Working Party on the Transport of Perishable Foodstuffs

Proposals of amendments to the ATP: Pending proposals

Proposal on the interpretation of external surface area measurement for panel vans

Transmitted by the United Kingdom

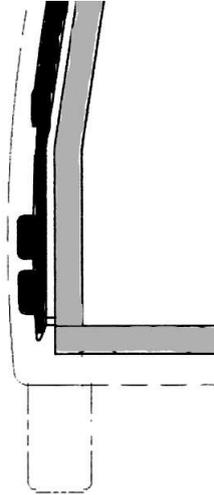
4. The point is illustrated in the diagram below. The grey shading represents the main insulated panel and the black voids represent varying thicknesses of foam infill. The question is whether the external surface should be considered as the outer edge of the grey part or whether it should include the voids and be loosely considered as the external metal surface.

Method 2

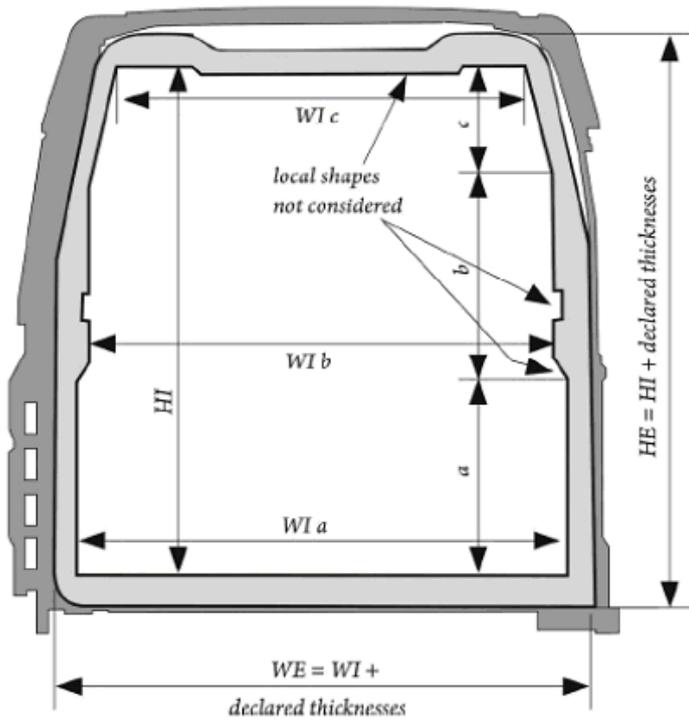
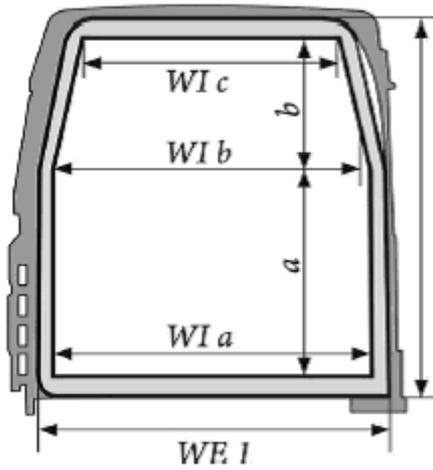
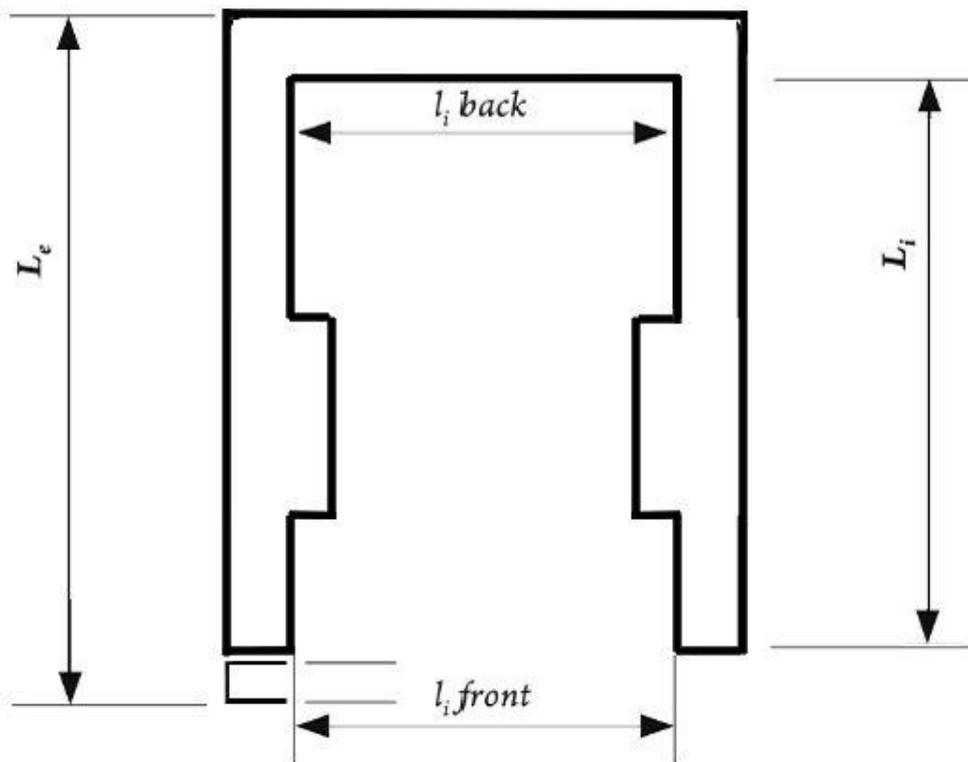
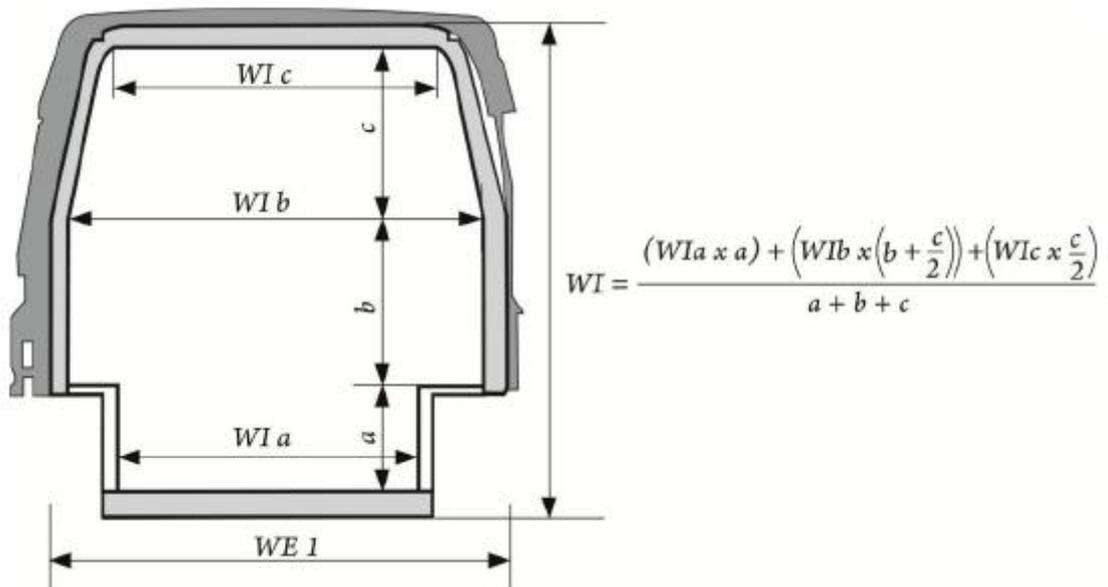
The manufacturer shall provide drawings and calculations according to the schemes and formulae as follows:

$$WI = \frac{WIa \times a + WIb \times \left(b + \frac{c}{2}\right) + WIc \times \frac{c}{2}}{a + b + c}$$

$$\text{Mean declared thicknesses (mm)} < \frac{2S}{K}$$

$$WI = \frac{WIa \times \frac{a}{2} + WIb \left(\frac{a}{2} + \frac{b}{2}\right) + WIc \left(\frac{b}{2}\right)}{a + b}$$

$$l_i = \frac{l_i \text{ back} + l_i \text{ front}}{2}$$

$$WI = \frac{(WI a \times a) + (WI b \times (b + \frac{c}{2})) + (WI c \times \frac{c}{2})}{a + b + c}$$

$WE = WI + \text{mean declared thicknesses}$

For insulated panel vans, the external surface area shall be considered as the inner dimensions plus the declared thickness of the insulation material. Localised shapes are not considered and the wheel arches are subtracted from the final calculation.
